UNITED STATES PATENT AND TRADEMARK OFFICE

10/588,463

Stefan Vogelin

DETAILED ACTION

Fig A

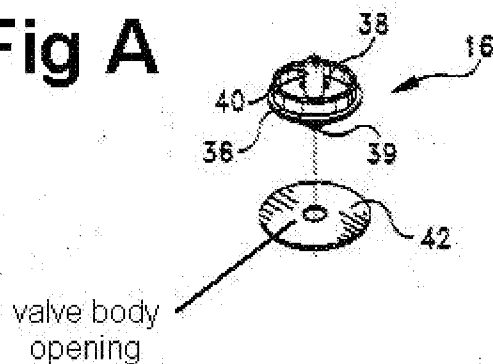
Fig A below) which are offset relative to one another (best shown in Fig A below) and which form a free passage when the diaphragm of the valve body lifts (Col 4, Lines 18-24), the valve body having the same basic shaped as the valve seat (both circular as seen in Fig 3). Samson does not disclose that the diaphragm valve body comprises elongate openings which are uniformly distributed along a circle in the periphery of the diaphragm and wherein the elongate openings are separated from one another by webs, the diaphragm designed to be weaker in the area adjacent to these webs or that the valve body comprises the diaphragm and a cylindrical jacket that surrounds the diaphragm, wherein the valve body is a unitary part, and wherein the jacket can be fitted over the valve seat. Zelson, however, teaches a valve 10 (Fig 2,5) having a valve seat 32 (Fig 2) and a valve body 30 (Fig 5) with a circular diaphragm (formed by pieces 22,12,14 as seen in Fig 5), the valve body being arranged over the valve seat and closing the valve seat sealingly when it bears on said valve seat (Para 76), and the valve seat and valve body having openings (as seen in Fig 2,5) which are offset relative to one another (as seen in Fig 2) and which form a free passage when the diaphragm lifts (Para 76), wherein the valve body comprises elongate openings 18 (Fig 5) which are uniformly distributed along a circle in the periphery of the diaphragm (as seen in Fig 5) wherein the elongate openings are separated from one another by webs 12 (Fig 5), the diaphragm designed to be weaker in the area adjacent to these webs (weaker compared to portion 14 due to the difference in the widths of the portions), and wherein the valve body comprises the diaphragm and a cylindrical jacket (as seen in Fig C above) that surrounds the diaphragm, wherein the valve body is a unitary part and has

Fig B

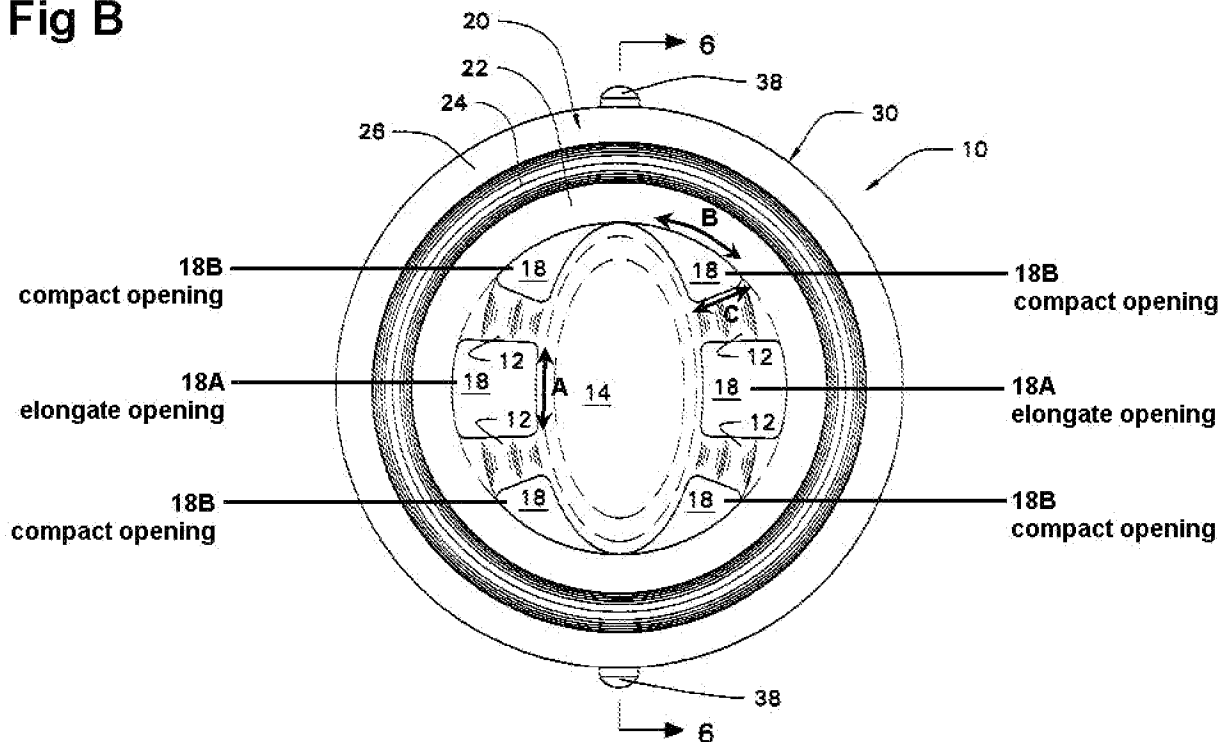
9. Re claim 30, Samson discloses all the claimed features except that compact openings are present adjacent to the webs and are arranged in the weakened area of the diaphragm. Zelson, however, teaches compact openings 18B (as seen in Fig B above) adjacent to webs 12 (Fig 5 and Fig B above) that are arranged in the weakened area (the area formed by portions 22 and 12 that are thinner than portion 14, Fig 2,5) of the diaphragm for the purpose of guiding and restrictively permitting the movement of the plugging portion of the valve in order to allow or prevent fluid to pass (Para 55).
